A RESOLUTION OF THE CITY COMMISSION OF THE CITY OF HOLLYWOOD, FLORIDA, RECOMMENDING AN AMENDMENT TO THE BROWARD COUNTY TRAFFICWAYS PLAN TO ADD THE "CONTEXT SENSITIVE CORRIDOR" DESIGNATION TO A PORTION OF DIXIE HIGHWAY/21ST AVENUE BETWEEN PEMBROKE ROAD AND SHERIDAN STREET.

**Re: Application for Broward County Trafficways Amendment
 Context Sensitive Corridor designation
 Dixie Highway/21st Avenue from Pembroke Road to Sheridan Street
 City of Hollywood**

RESPONSE TO COMMENTS

RE: Request to Amend Broward County Trafficways Plan
Dixie Highway / 21st Avenue (Pembroke Road to Sheridan Street)

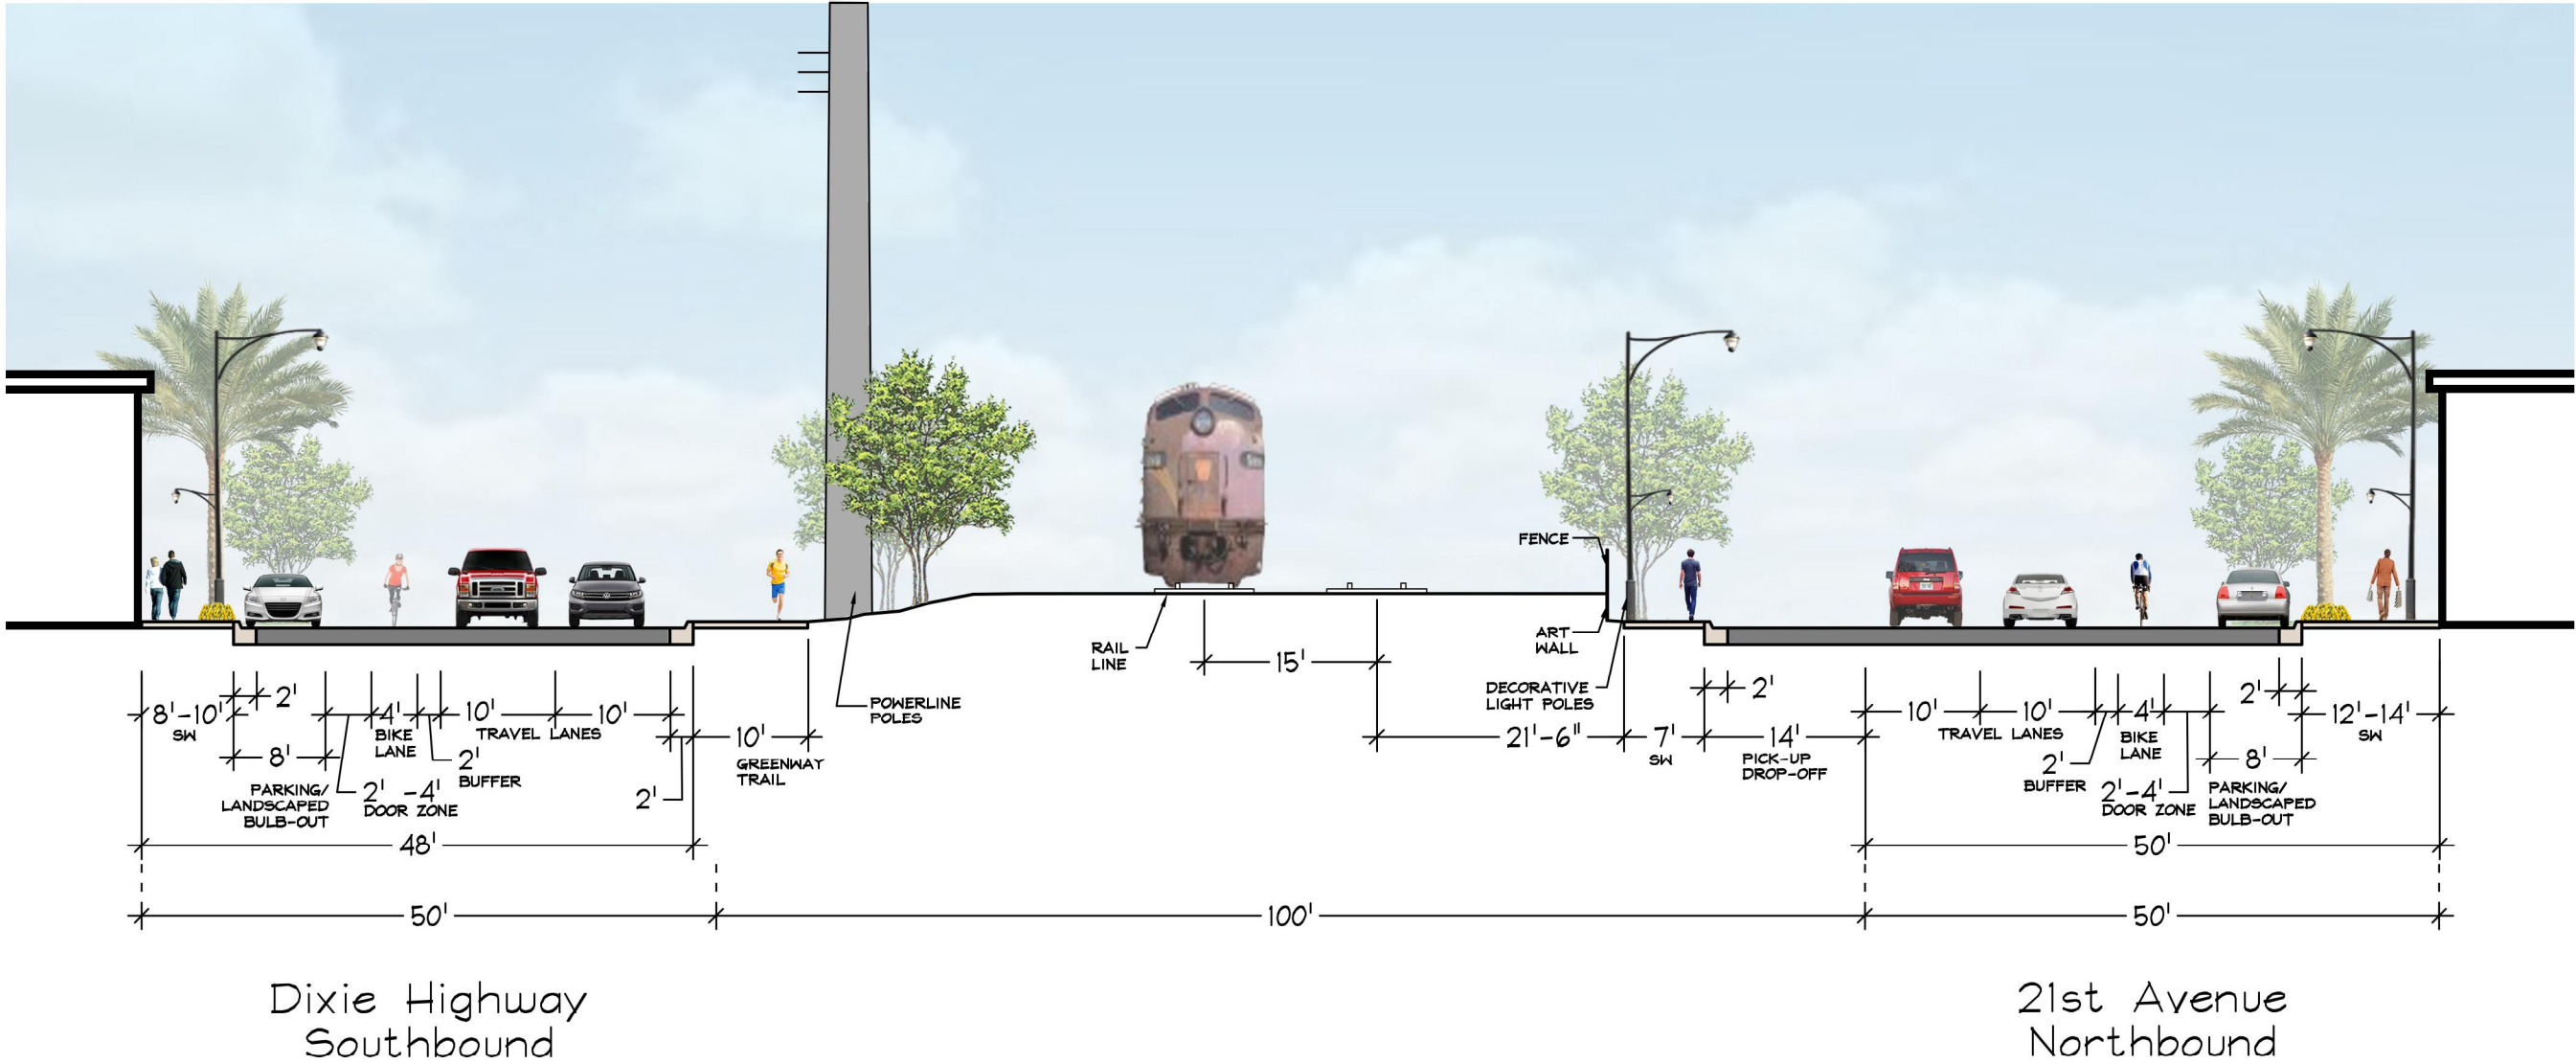
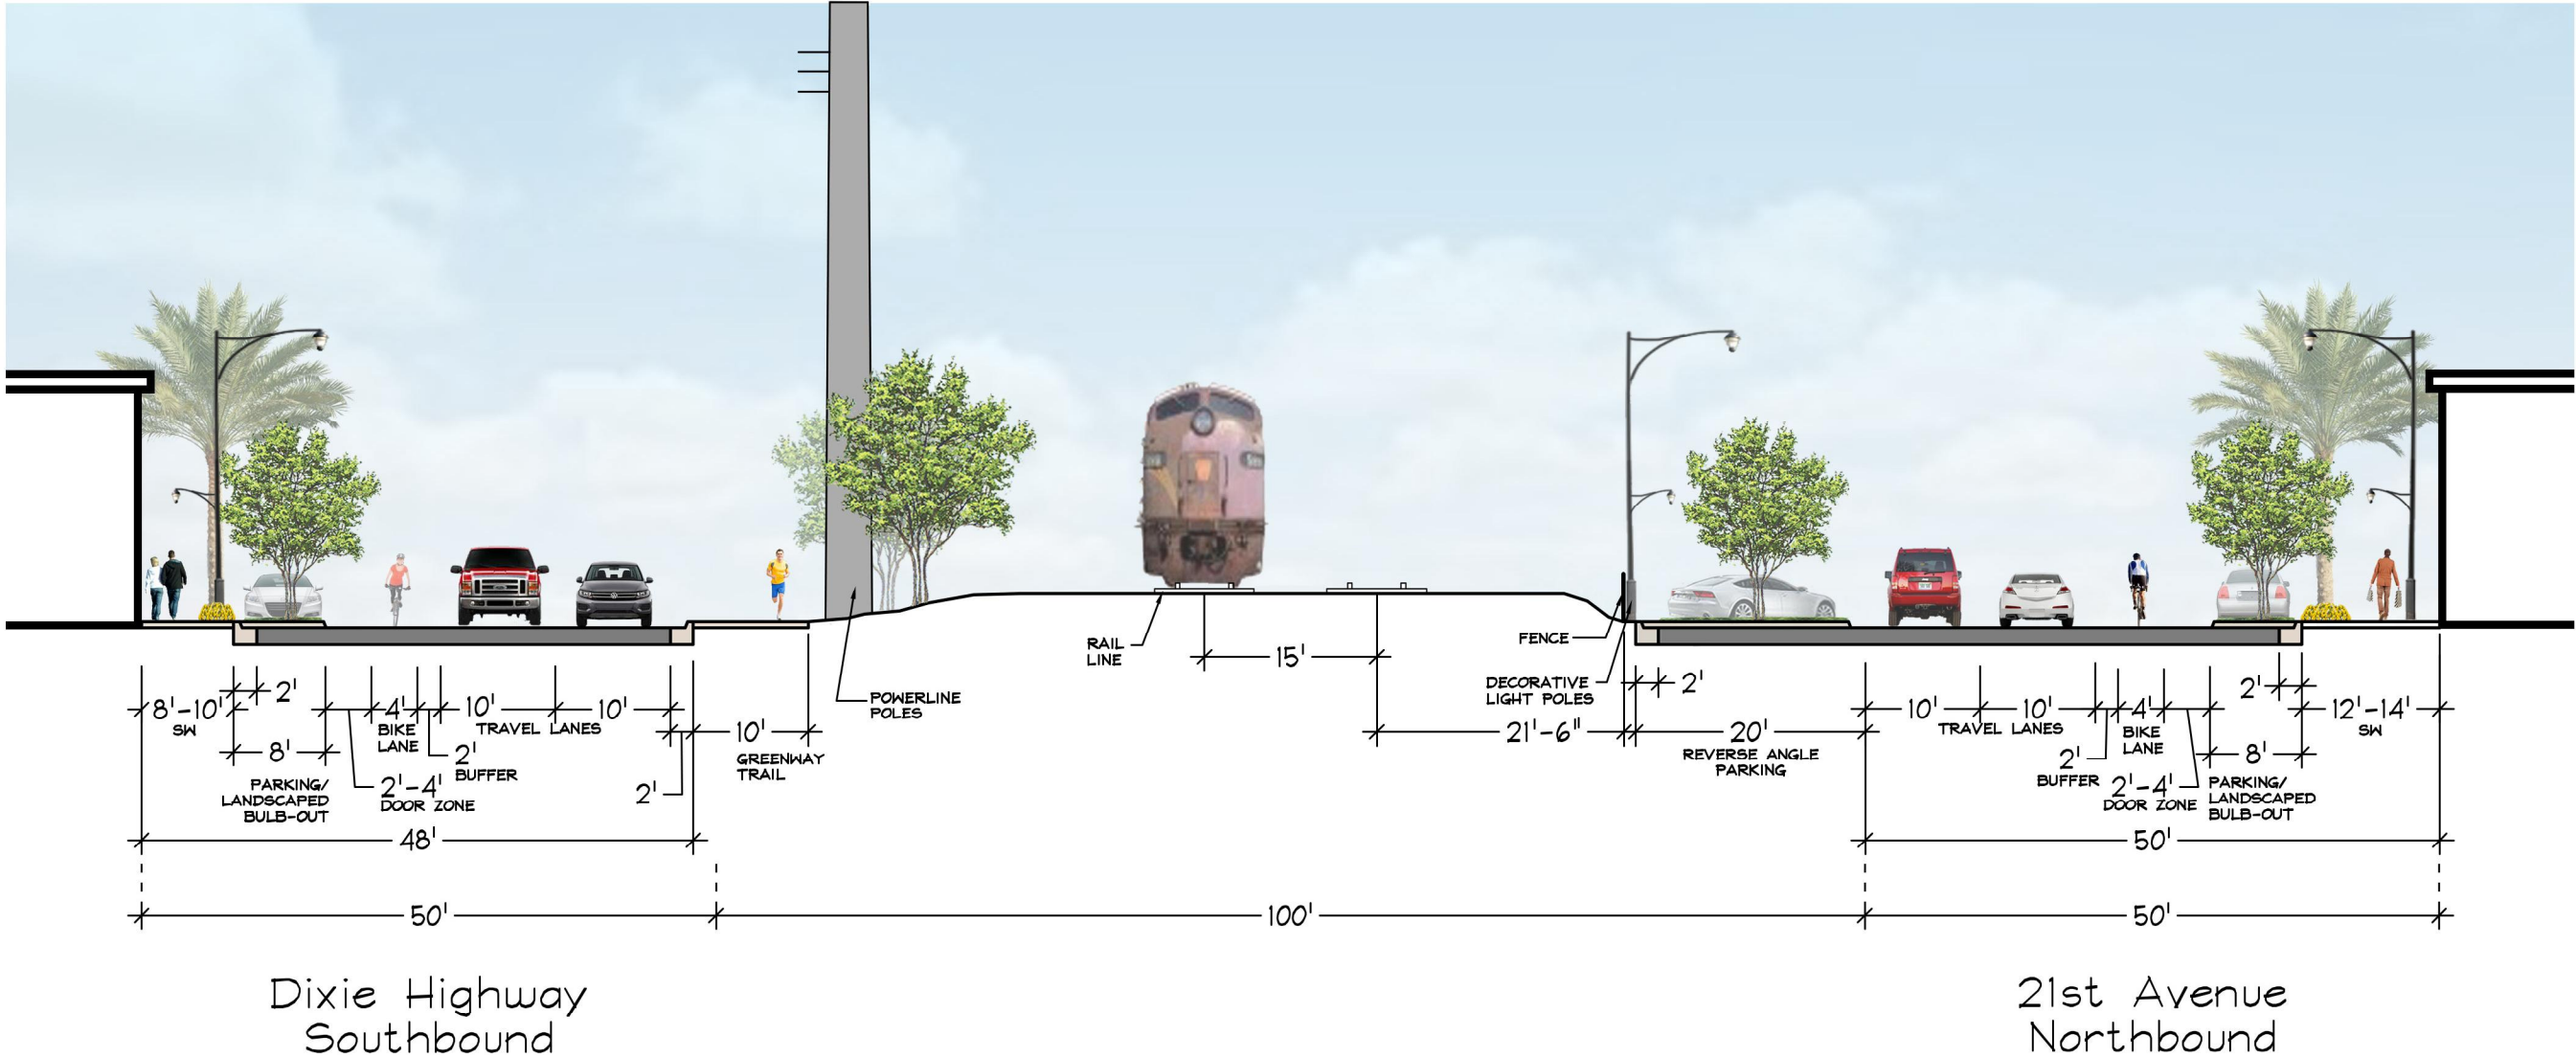
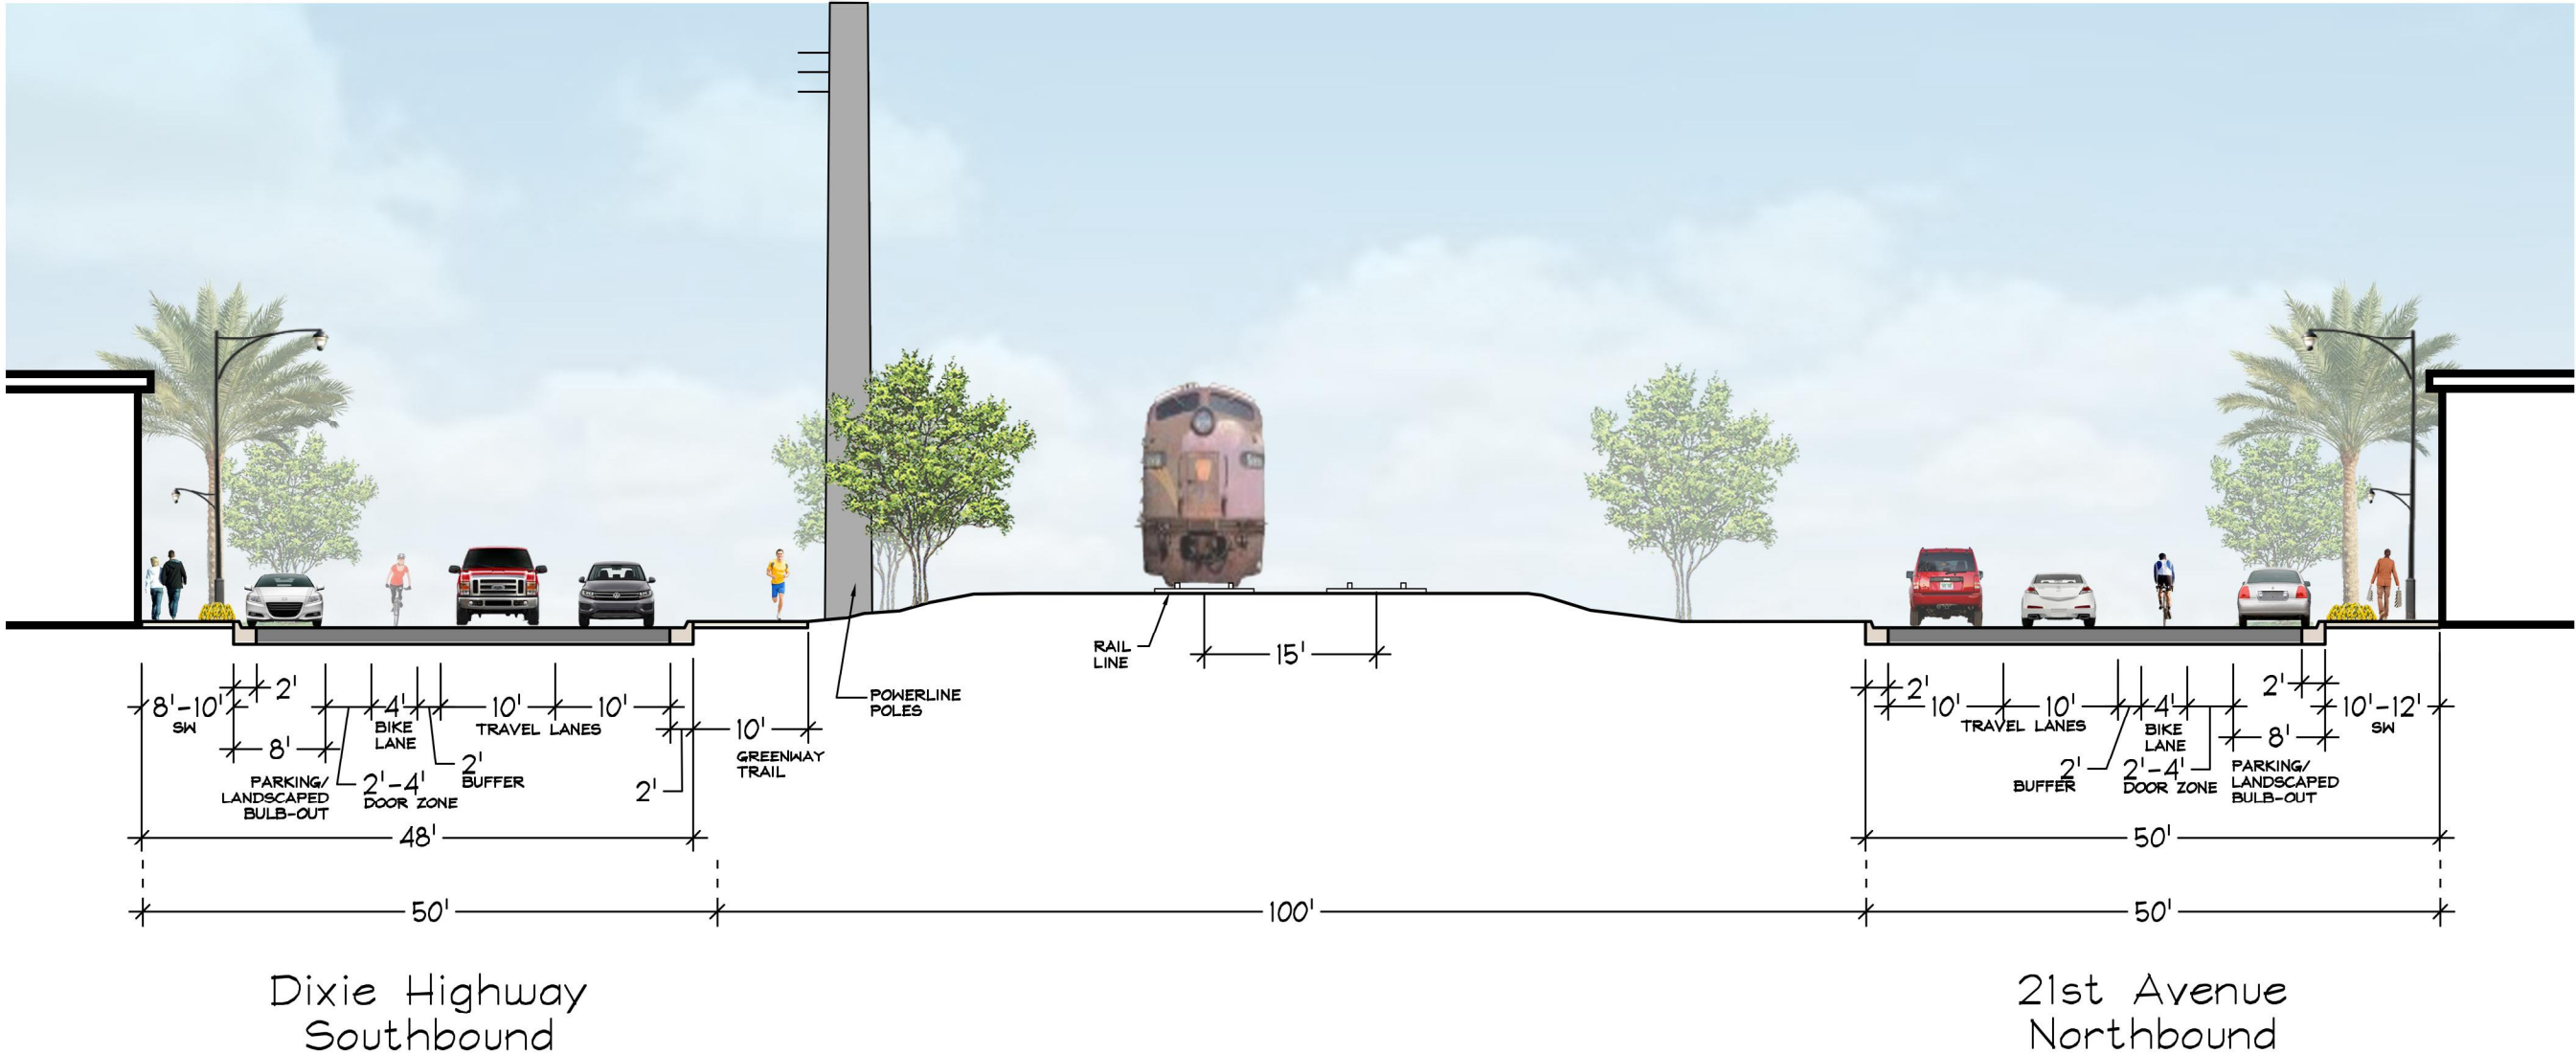
1. On-street parking is shown on Exhibits A, B, and C but is not specifically listed as a design element in Section A of the Letter of Application. All design elements proposed for the corridor including street trees, decorative lighting, etc. should be listed in the narrative in Section A.

1. On-street parking is shown on Exhibits A, B, and C but is not specifically listed as a design element in Section A of the Letter of Application. All design elements proposed for the corridor including street trees, decorative lighting, etc. should be listed in the narrative in Section A.

Response: On-street parking is included in the narrative for Section A; however, we modified the narrative to specify an eight (8) foot (including curb and gutter) on-street parking lane with intermittent landscaped bulb-outs. In addition, we modified the narrative for Section A to include street trees, landscaping, and decorative lighting.
